AGENDA
PLANNING & ZONING COMMISSION
OCTOBER 27, 2025
COMMISSION ROOM
MANDAN CITY HALL
5:30 PM
WWW.CITYOFMANDAN.COM

1. **Consider a building setback variance for Lot 1, Block 2, Meadows 2nd Addition.**
2. **Consider a Preliminary Plat to be named Meadowlands 3rd Addition and a Zone Change to RMH (Residential) for Proposed Block 2, Meadowlands 3rd Addition.**

1. **Consider a preliminary plat for Keidels South Heart Terrace 5th Addition and a zone change from R7 (Residential) to R3.2 & R7 (Residential).**

PRELIMINARY PLAT

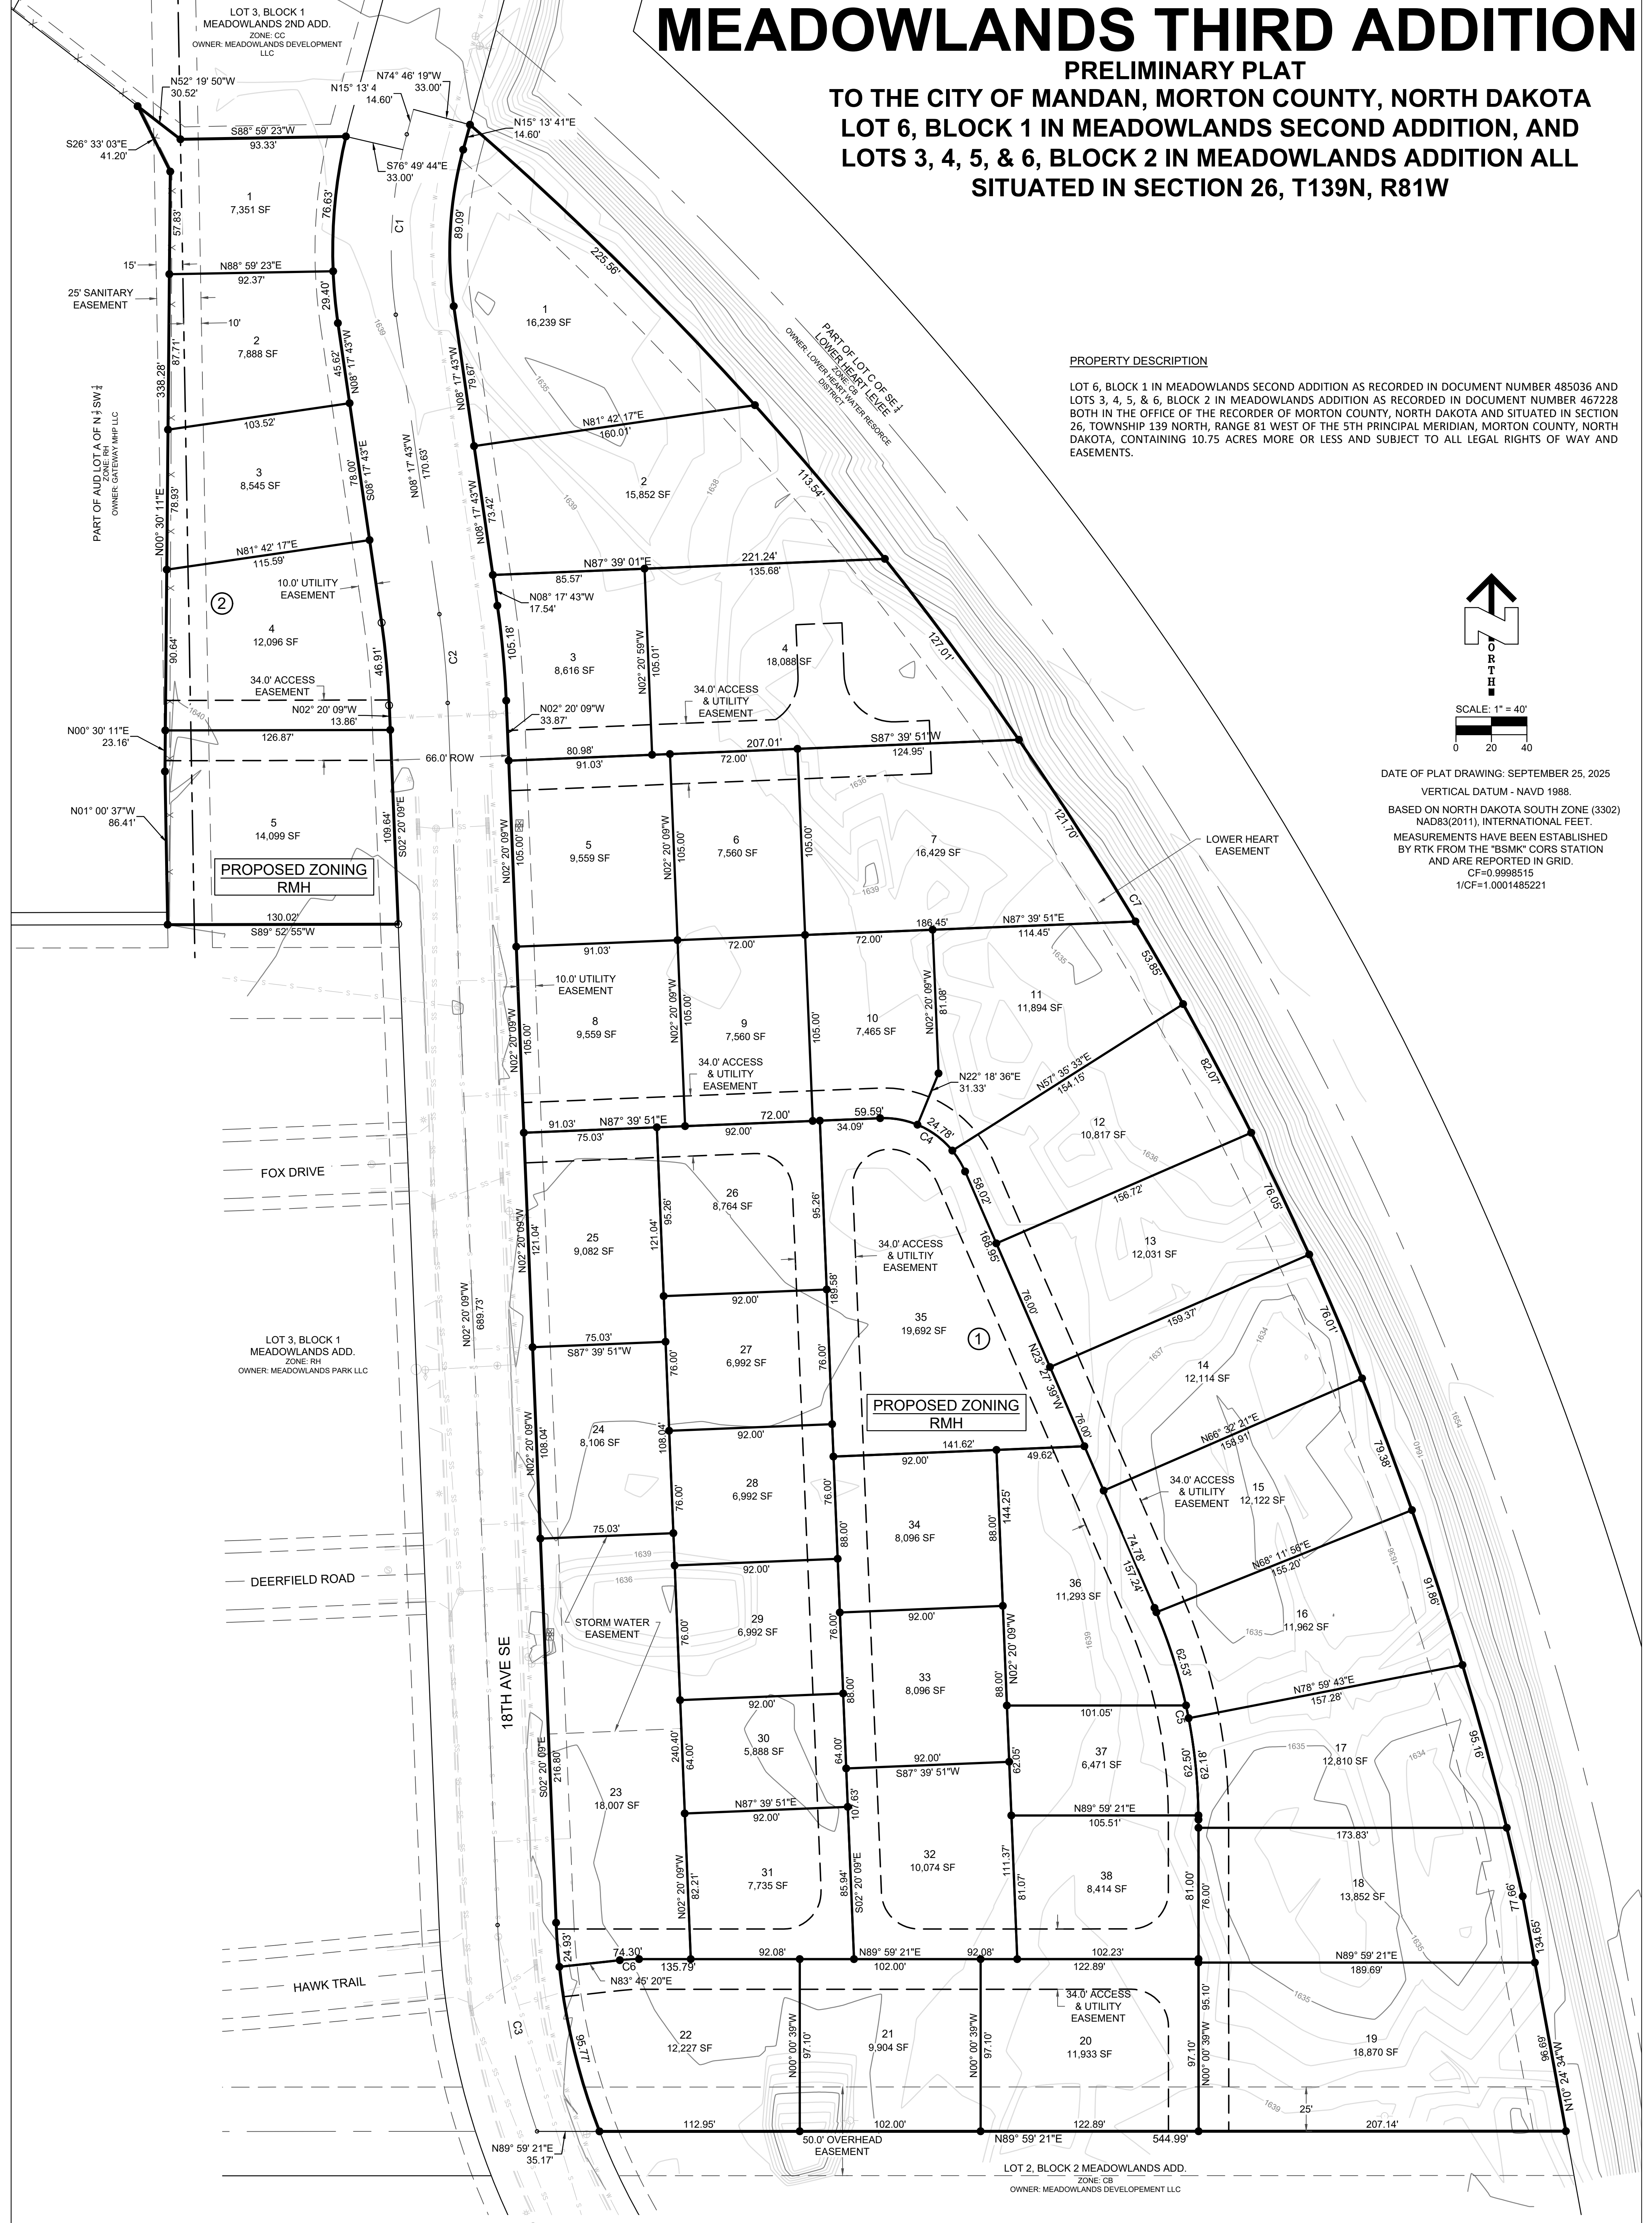
- Staff recommend that the applicant revise the terminating street to an appropriate cul-de-sac with adequate turnaround width.
- The plat does not indicate whether 18th Ave is planned to connect to Memorial Highway to the north. The NDDOT Memorial Highway reconstruction project does not indicate if existing access for BNSF property will be maintained, nor does it indicate whether 18th Ave will be extended to create an intersection at Memorial Highway. Without a connection to the north at Memorial Highway or to the west via S Frontier Trail, all traffic in the proposed development would ingress/egress via 18th Ave, similar to the homes at Meadowlands Park. The traffic impact of this is unknown. Based on required items from previous zoning approval, the applicant should provide a plan for connection to Memorial Highway.

Planning Staff recommends to table this preliminary plat and zone change request until such time as the applicant can provide detailed cross-sections of the 34' wide access and utility easements, confirm the buildability of all lots based on setbacks and buffers, provide a plan for connection of 18th to Memorial Highway, and confirm with all relevant departments including emergency management that the wye intersection is acceptable in place of a cul-de-sac on a private street.

KEIDEL'S SOUTH HEART TERRACE 5TH ADDITION

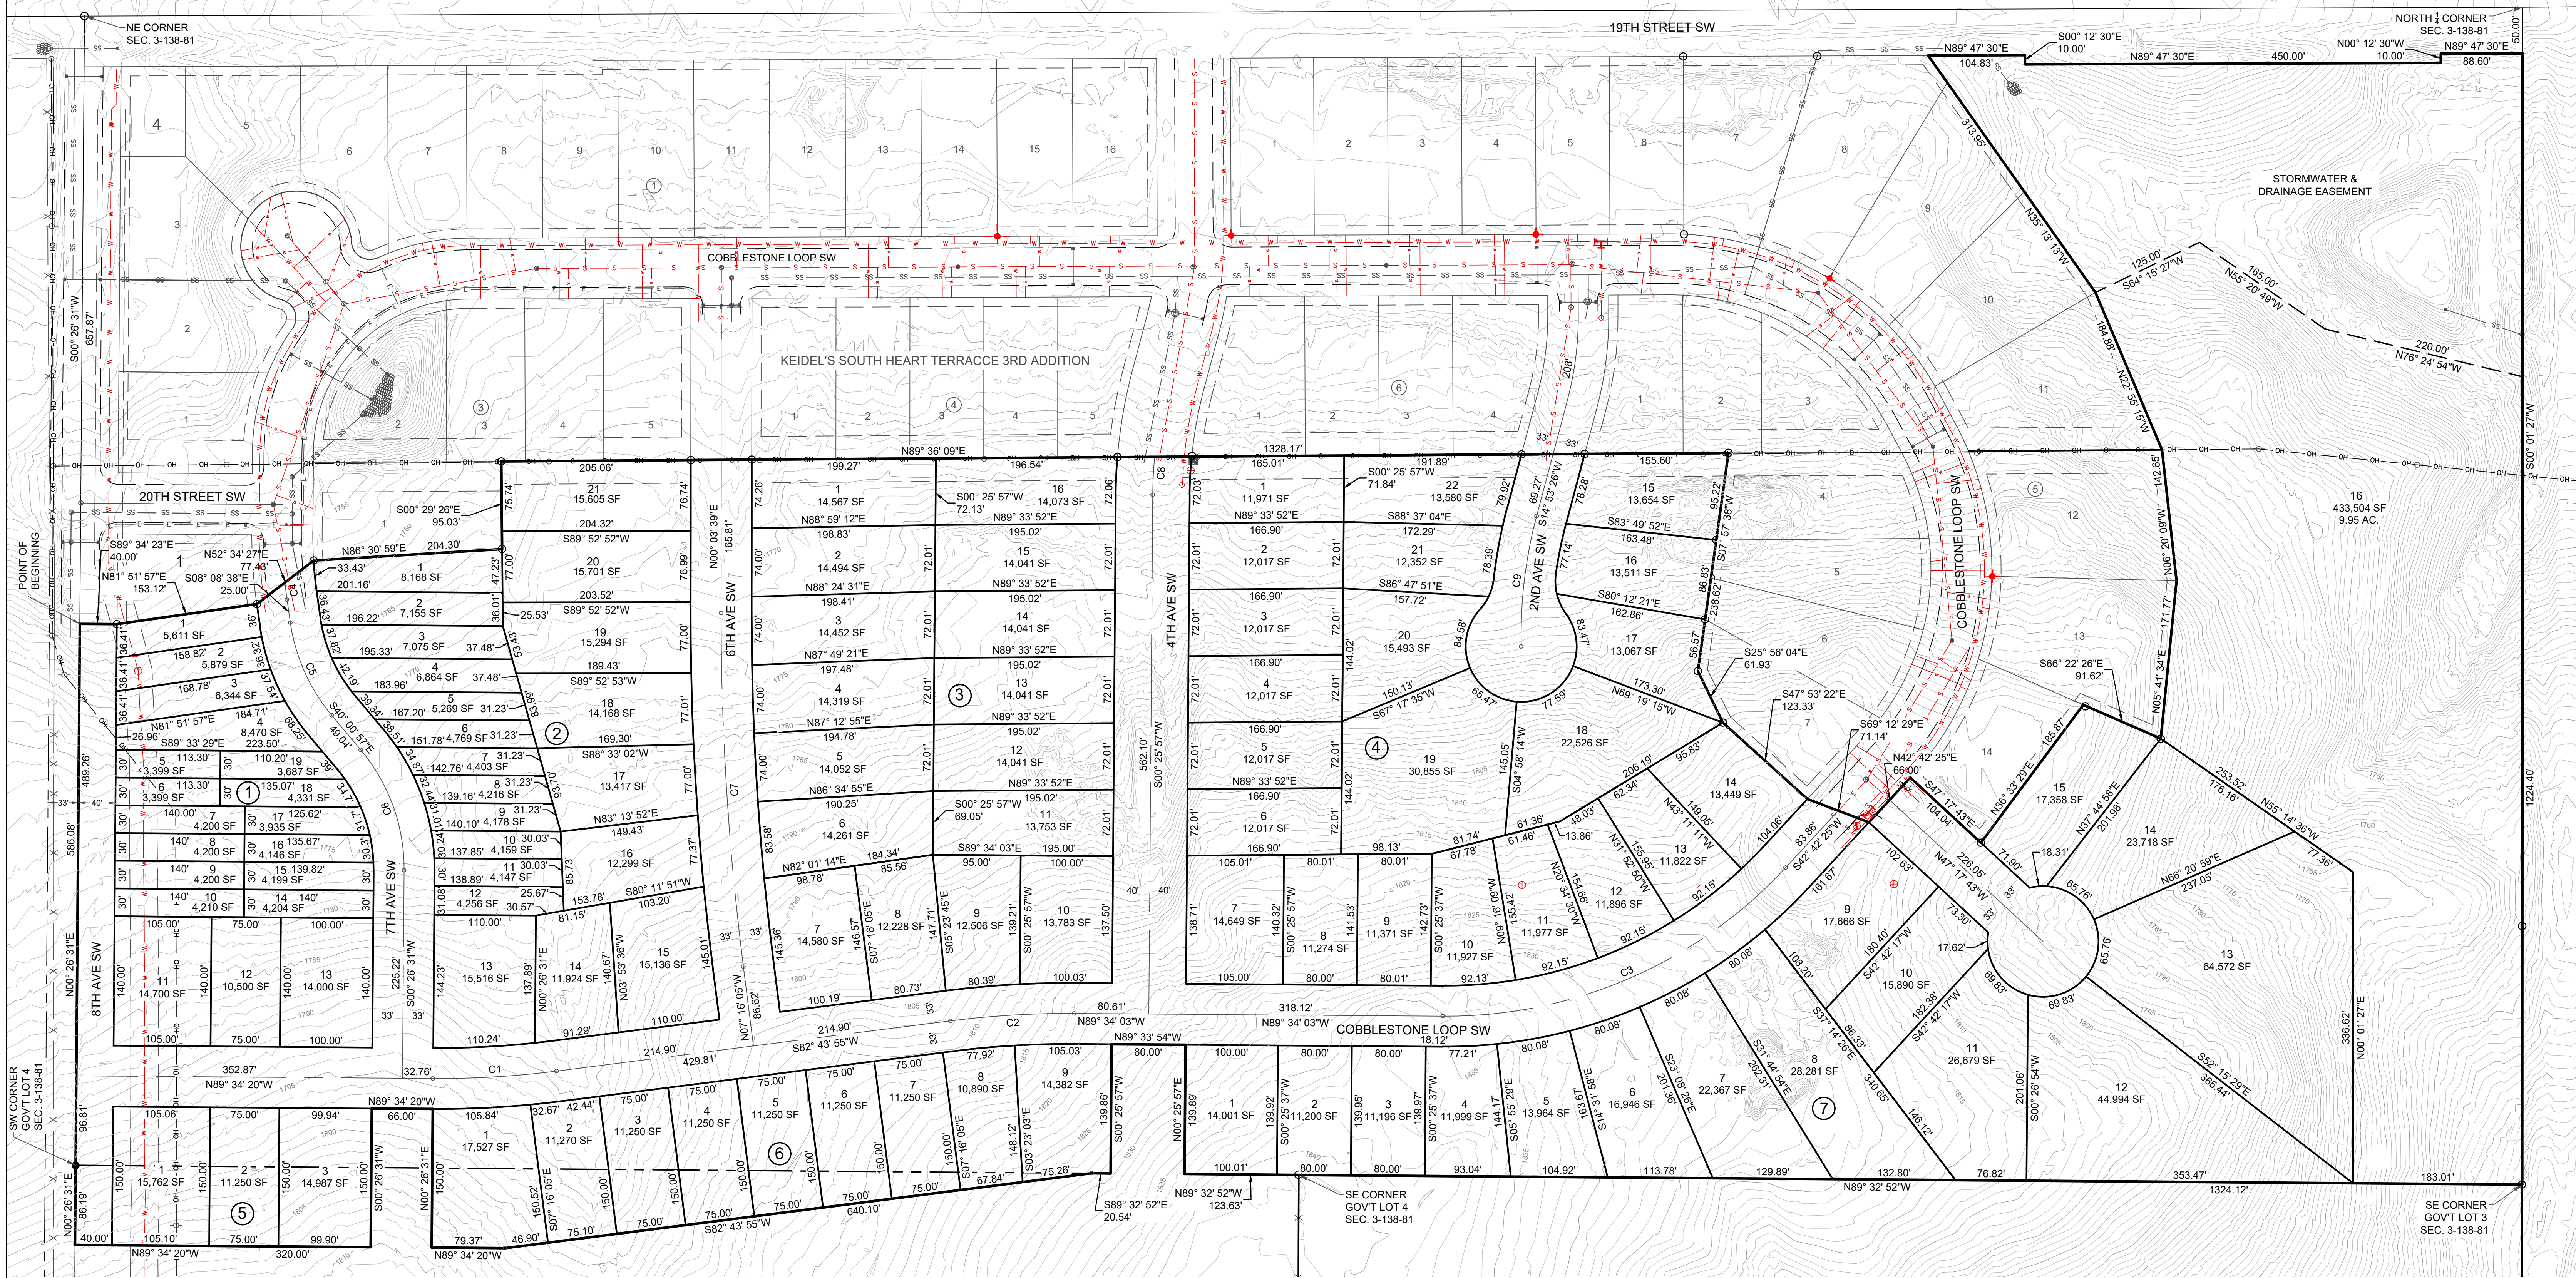
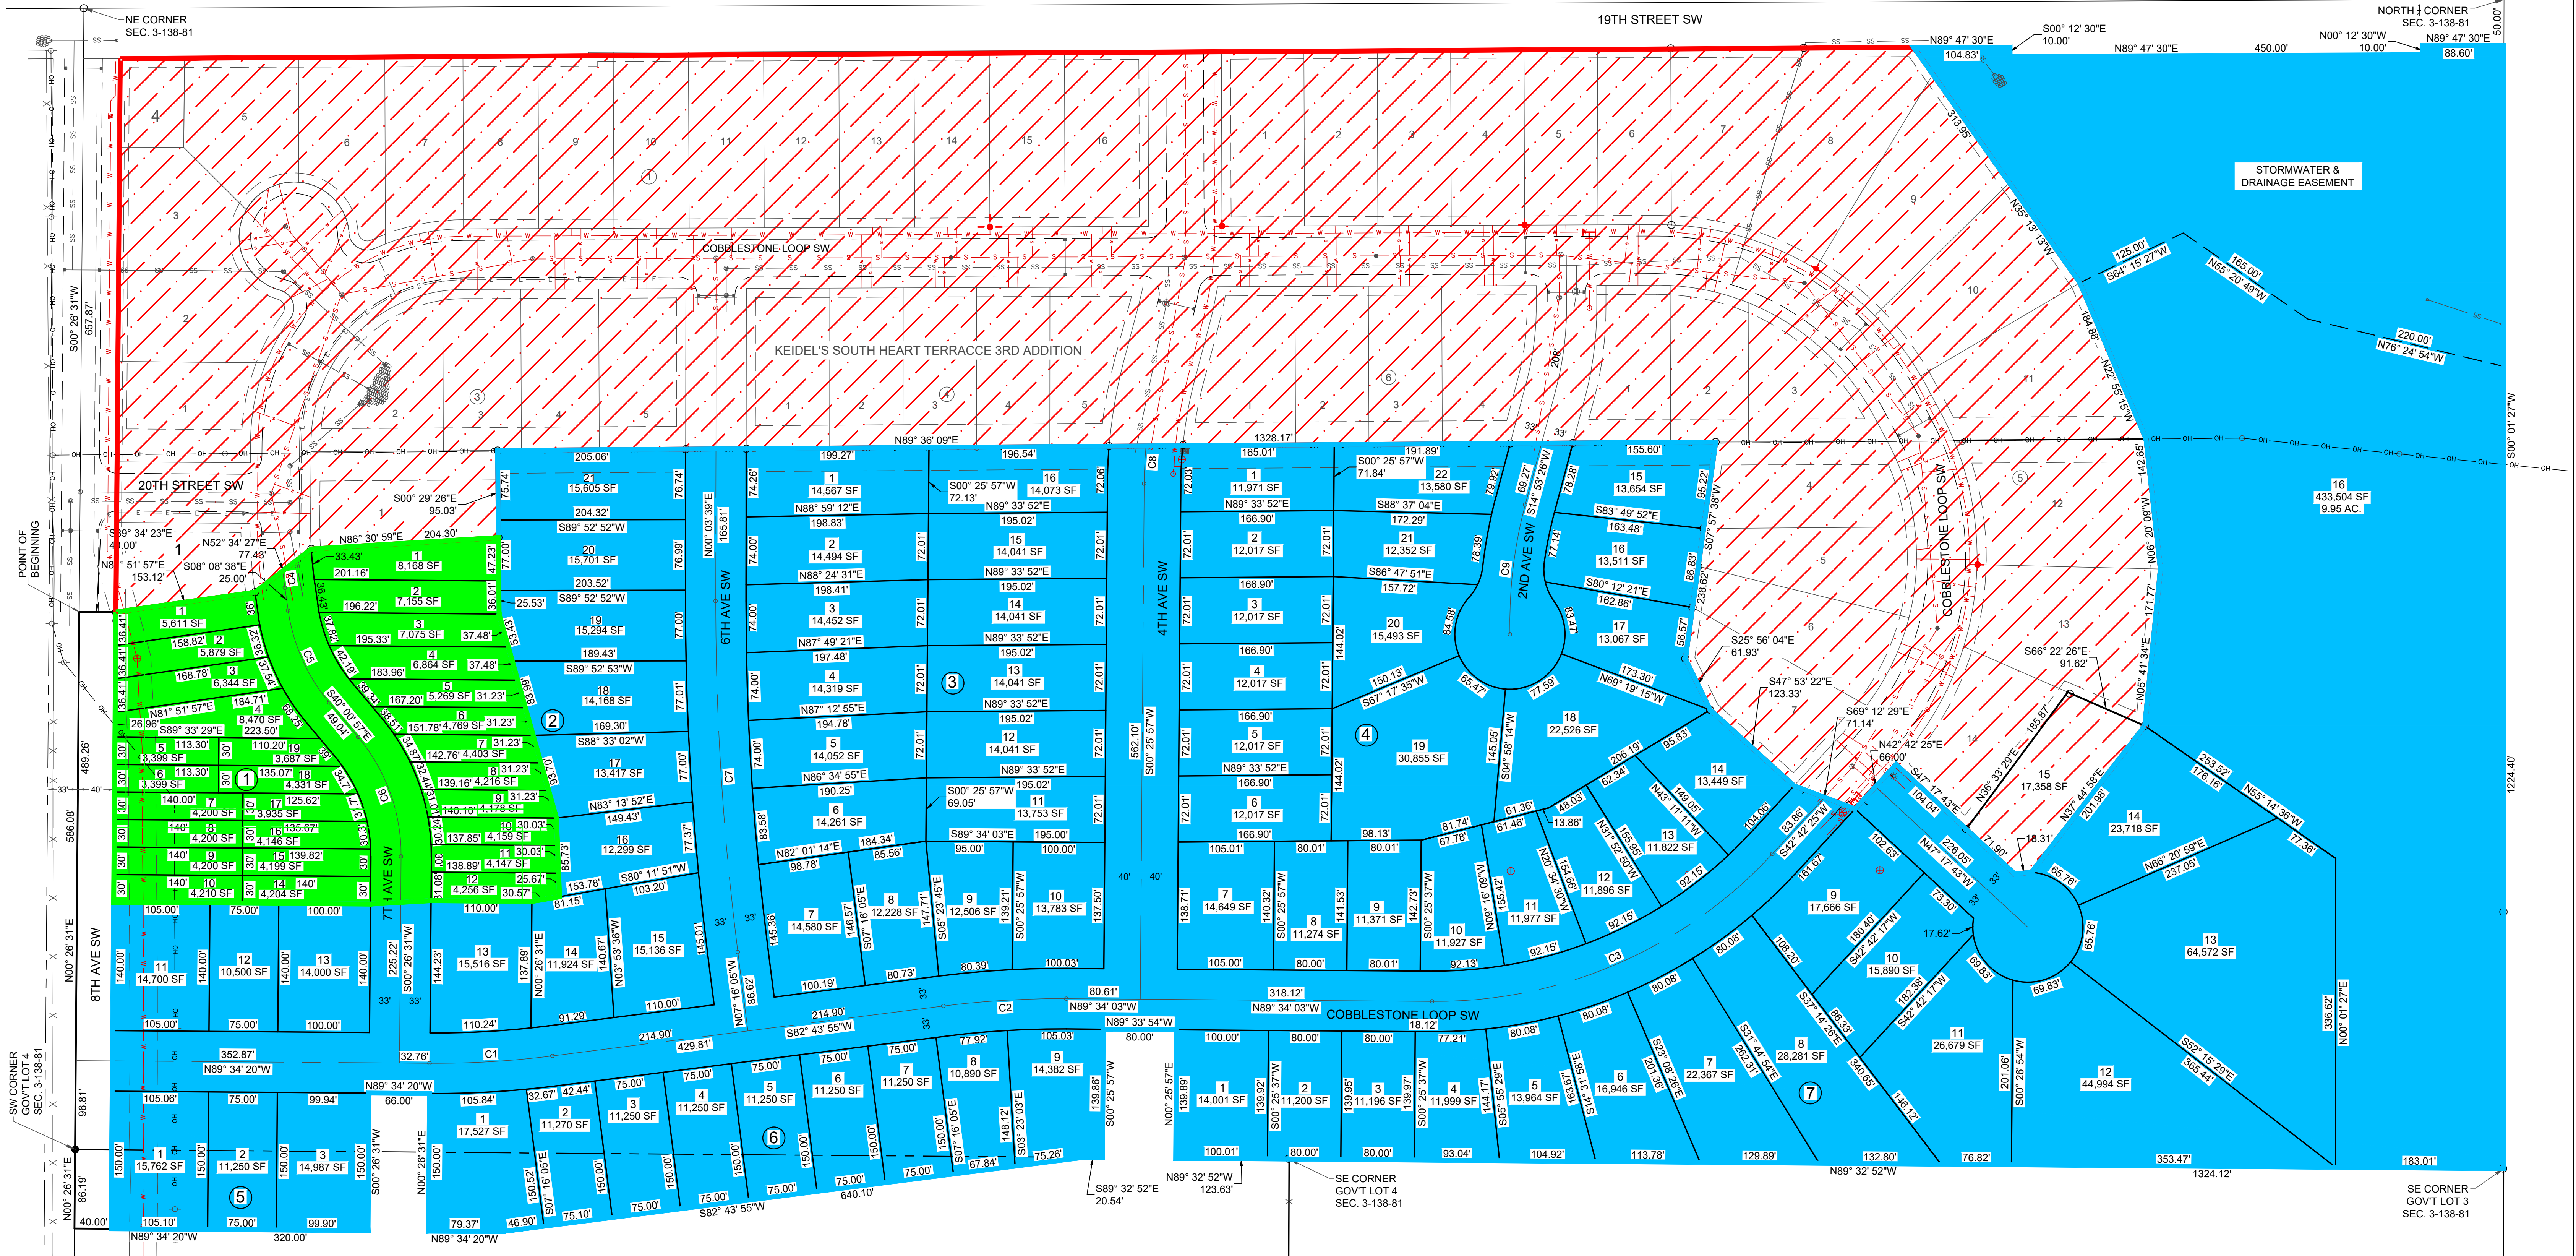
- Staff has requested that the owner and applicant work with the neighboring property to the east, to be developed as Clover Grove PUD, to provide a valuable cross-connection point between to the two subdivisions. Neither subdivision will meet access management requirements at full build-out without the cross-connection between subdivisions. The two owners have agreed to work together to connect streets and sewer. The connection street will be added on the east side of this proposed subdivision where the proposed cul de sac on the southeast side is shown. There will be lots added to the subdivision to accommodate this connection.

- The plat shows an overhead transmission line which will make Lots 21, Block 2, Lots 1 and 16, Block 2, Lots 1, 22 and 15 of Block 4 very narrow and potentially unbuildable, though they meet minimum width requirements.

- The plat will dedicate 40' of additional ROW on 8th Ave SW, matching the existing street section to build within 73' of ROW.
- 8th Ave SW will need to be extended to the intersection of Cobblestone Loop SW, and will need to include sidewalks on the east side.

- The Park District has requested a park between 4th Ave SW and 5th Ave SW and is working with the owner.
- The legal description of the plat should include 'part of Government Lots 3 &4 and the NW1/4 of Section 3, T138N R81W.

- Phasing plan should be shown and approved for preliminary plat approval.
- Stormwater lot in this plat and the prior plat should be held in undivided interested between benefiting
